AGENDA
SEPTEMBER 22, 2026
CITY OF LAVON
PLANNING AND ZONING COMMISSION
CITY HALL, 120 SCHOOL ROAD, LAVON, TEXAS
6:30 PM

Re: Lake Breeze, Lot 4
Revised Site Plan Review
LJA Job No. NTP-3880
MyGov Submittal: September 16, 2026

SITE PLAN

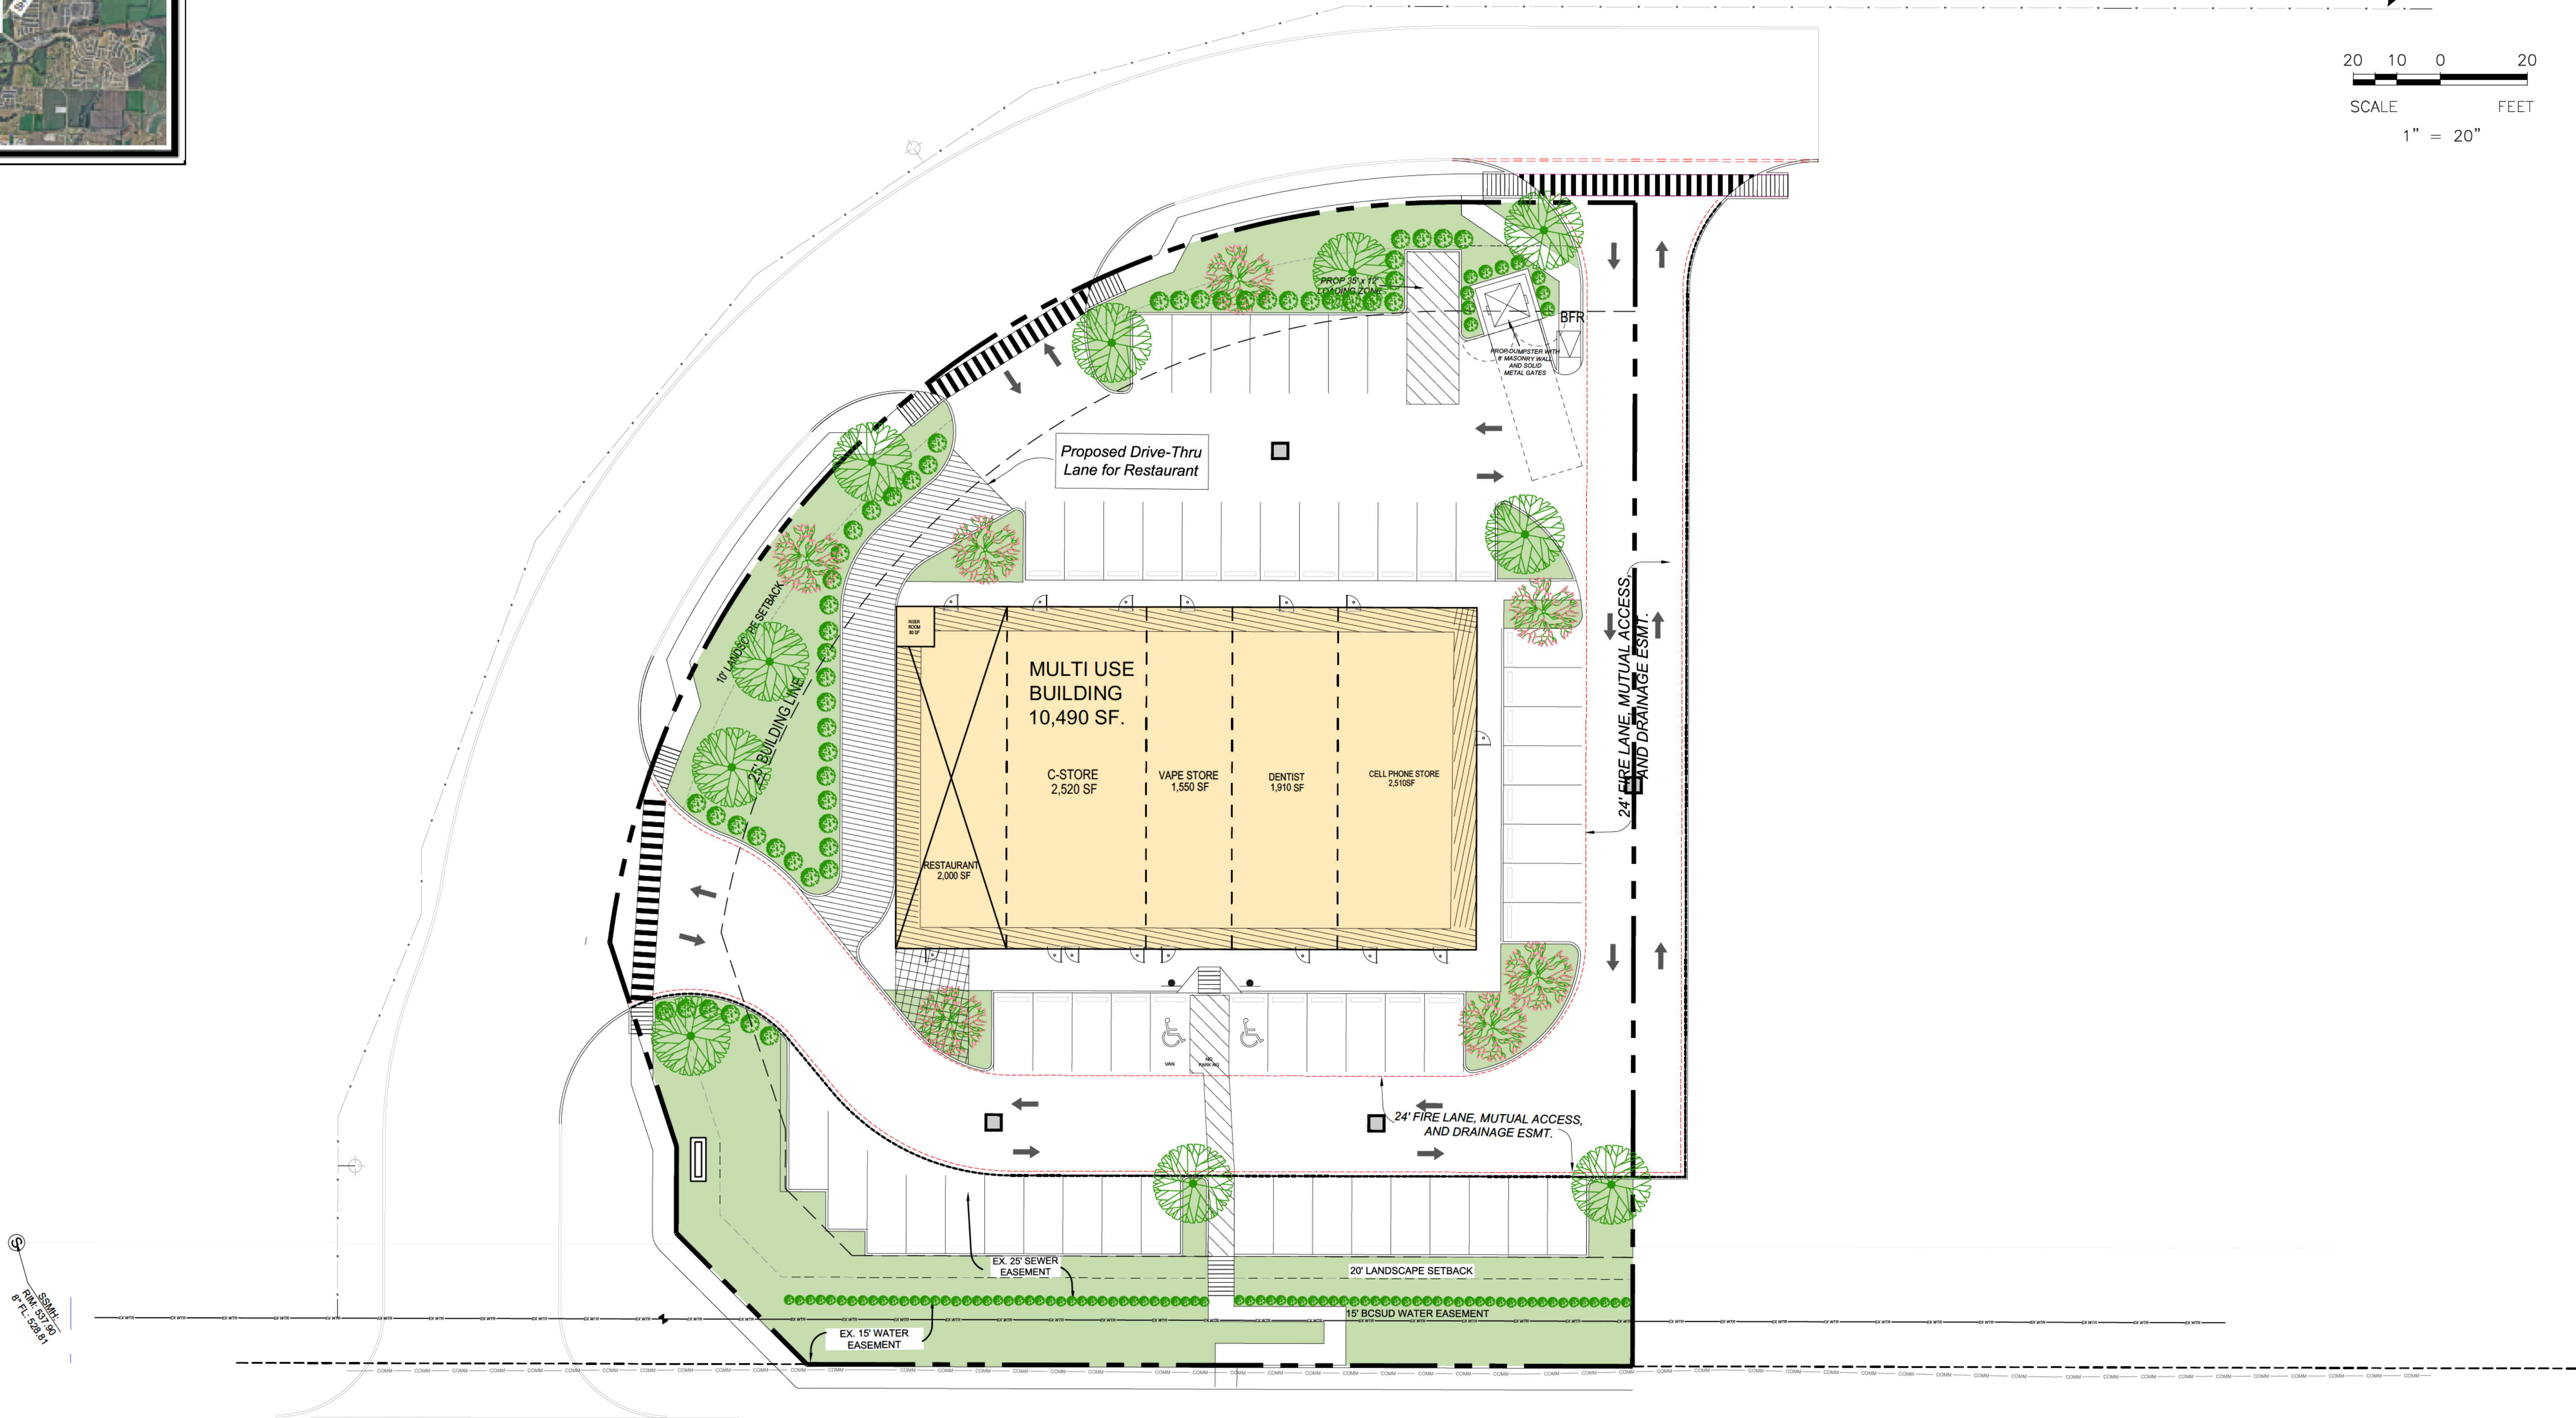
1. On the CUP Site Plan Exhibit, provide the filing information for the onsite portion of the 24' Fire Lane, Drainage, and Mutual Access Easement by separate instrument.

3. **REPEAT COMMENT:** Revise the Site Plan to provide the filing information for the onsite portion of the 24' Fire Lane, Drainage, and Mutual Access.

The filing information does not appear to be included. Revise the Site Plan to include the filing information for the onsite portion of the 24' Fire Lane, Drainage, and Mutual Access Easement by separate instrument.

4. **REPEAT COMMENT:** The parking ratio for restaurant and retail have changed since the prior Site Plan was approved. Revise the Site Data Table to reflect the following parking requirements per § 9.03.032 Permitted Use and Parking Table. The Site is required to have 63 parking spaces total. Revise the Site Plan and Landscape Plan to provide the minimum number of required parking spaces accordingly.

The Site Plan has been revised to provide the required number of parking spaces. However, the Project Site Data Table shows incorrect ratios. Revise the Project Site Data Table to reflect the updated parking ratios. See table below.

1. **REPEAT COMMENT:** A CUP is required for the location of the proposed drive-through, and could be required for any potential alcohol sales. Furthermore, "Vapor smoking services" is not a permitted use. Revise the Site Plan to remove the Vape Store from the tenant label and Site Data Table.

Site Plan has been revised to remove the Vape Store from the tenant label and Site Data Table. However, a CUP could be required for any potential alcohol sales. Please confirm if any proposed tenants will sell alcohol.

4 BACK ELEVATION
1/8" = 1'-0"

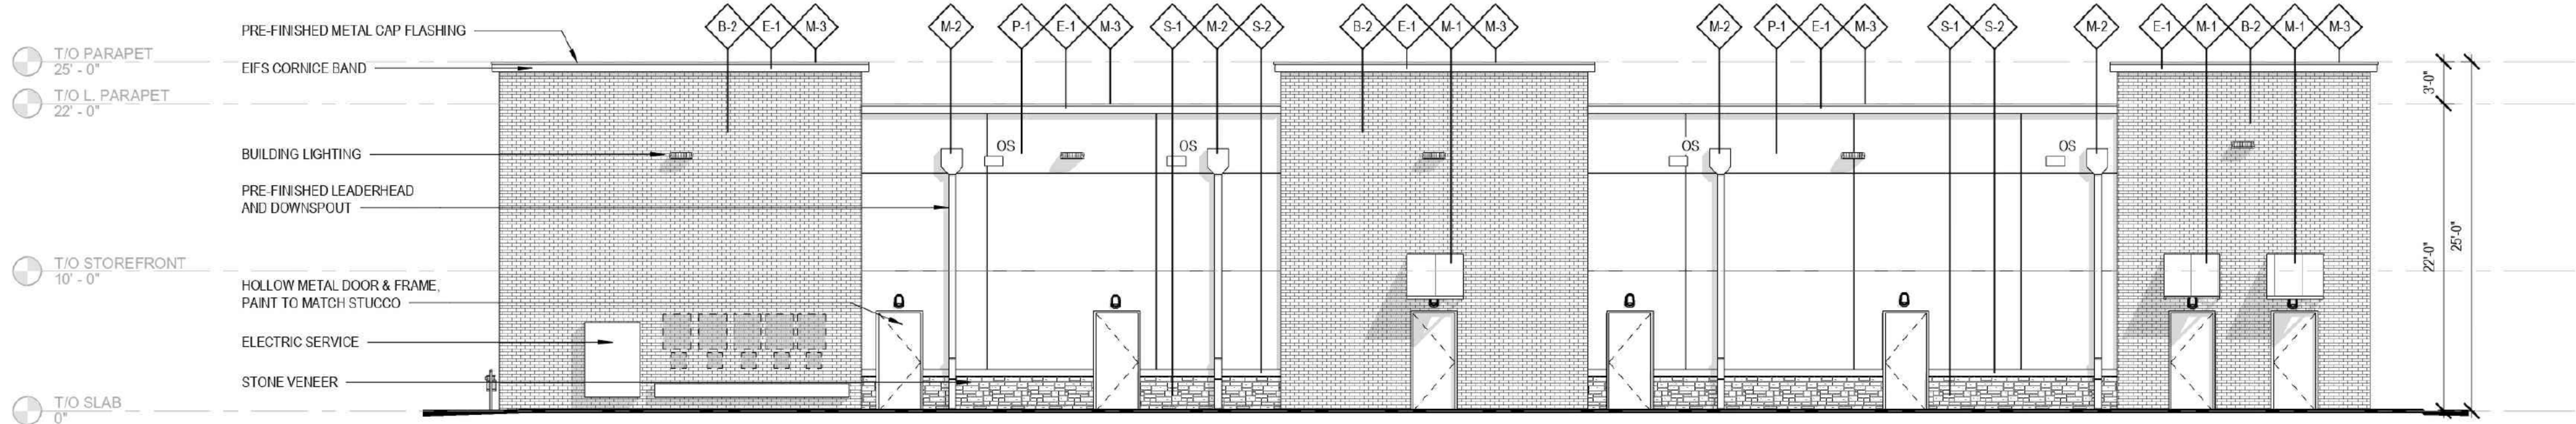
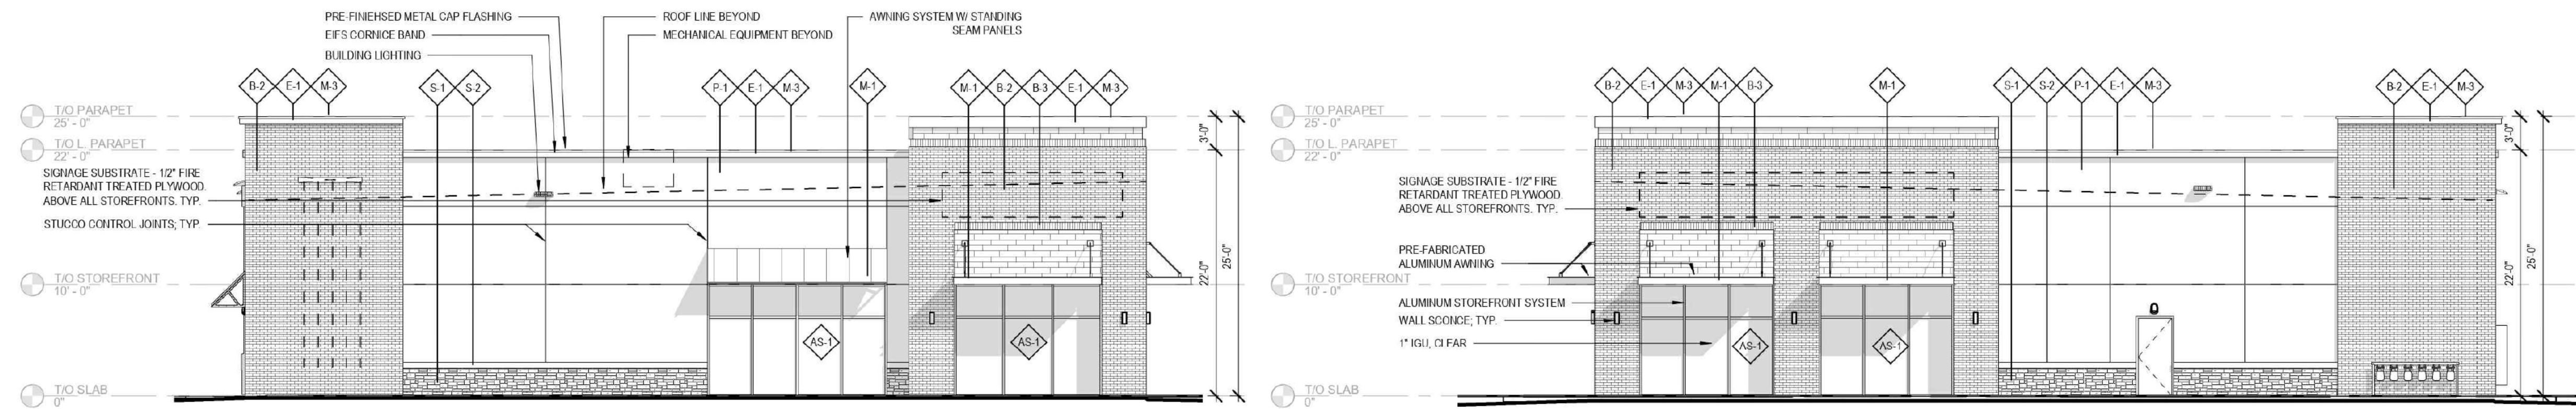
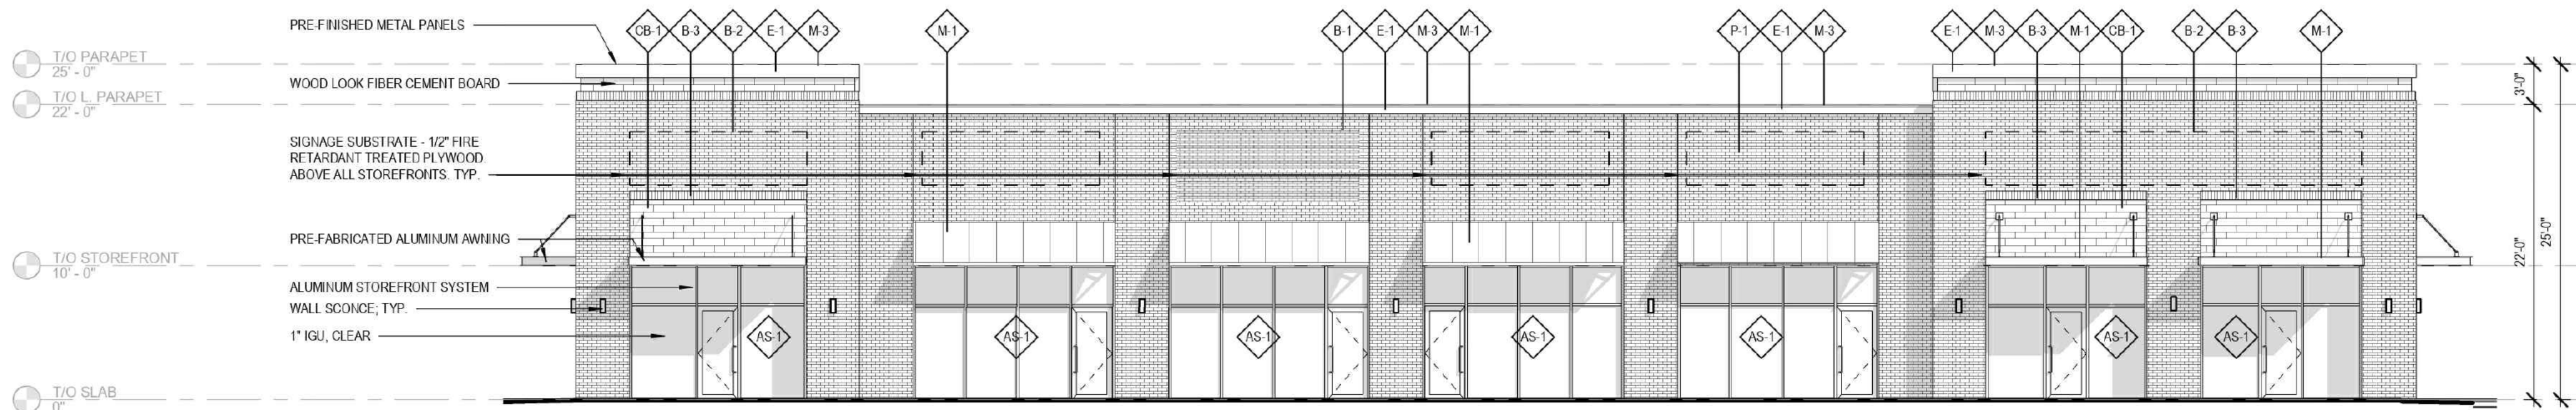
The Photometric Plan has been revised to match the revised Site Plan. However, the Building Elevations appear to show six tenant spaces while the Site Plan shows five tenant spaces. Please confirm the number of tenants and revise the associated plans accordingly.

Addressed and Updated on plan
